Video Products Technical Bulletin 30-2008-034

SUBJECT: REUSE TRANSFORMERS WHEN REPLACING GA BOARD

MODEL: ***BVM-1415P***
BVM-1416P
BVM-2015P

Figure 1

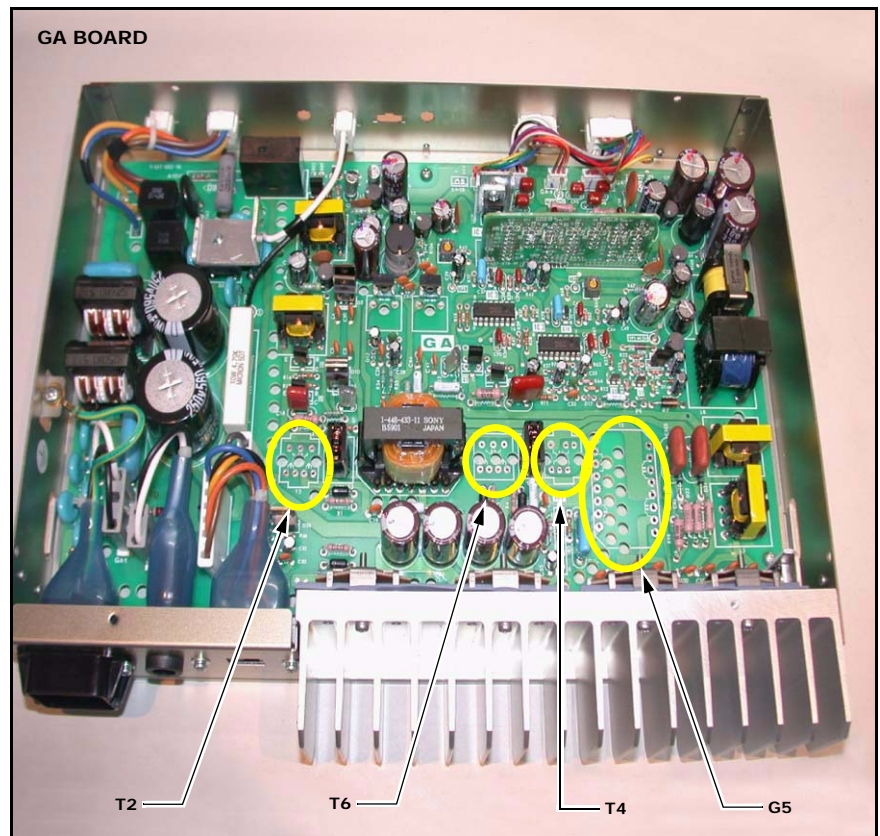
When you replace the GA board (A-1316-090-B), remove the following transformers from the former board and install them on the new board.

Ref. No.	Description
T4	Converter transformer Y
T5	Converter transformer (SRT)
T2 and T6	Drive transformer

The new GA board does not contain the transformers, and the transformers are no longer available. (See Figure 1.)
